To: T10 Technical Committee
From: Rob Elliott, HP (elliott@hp.com)
Date: 10 March 2004
Subject: 03-354r2 SPC-3 Specify initiator ports in EXTENDED COPY target descriptors

Figure 1 — Example of a complex copy manager environment

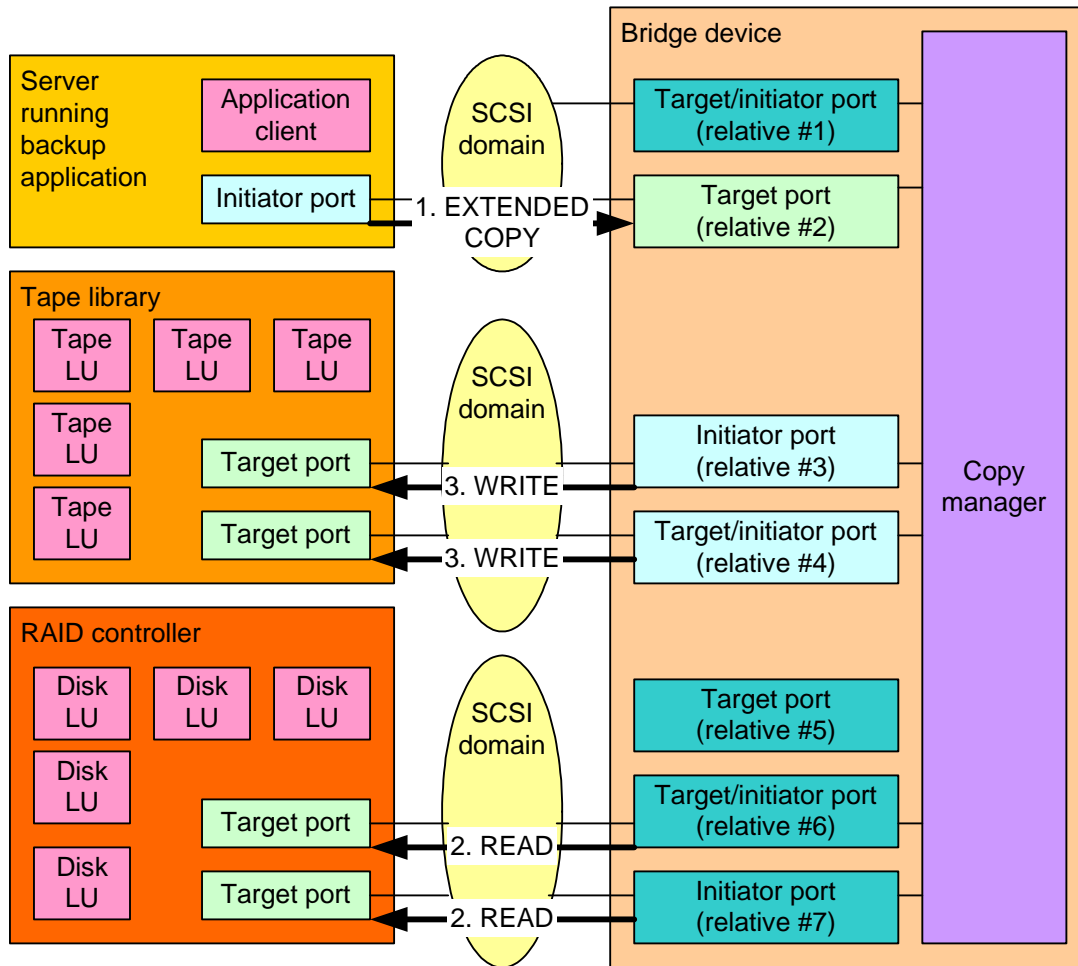
1. Send EXTENDED COPY to copy manager through target port #1 (or #2)
2. Copy manager reads from disks using initiator ports #6 and/or #7
3. Copy manager writes to tapes using initiator ports #3 and/or #4
4. EXTENDED COPY completes through target port #1 (or #2)

EXTENDED COPY is silent today on which initiator port to use. This proposal adds a relative initiator port field to the EXTENDED COPY target descriptor so an initiator port to use can be specified. The default value of zero means the choice is vendor-specific (the copy manager can use any initiator port it wants), which is compatible with current implementations.
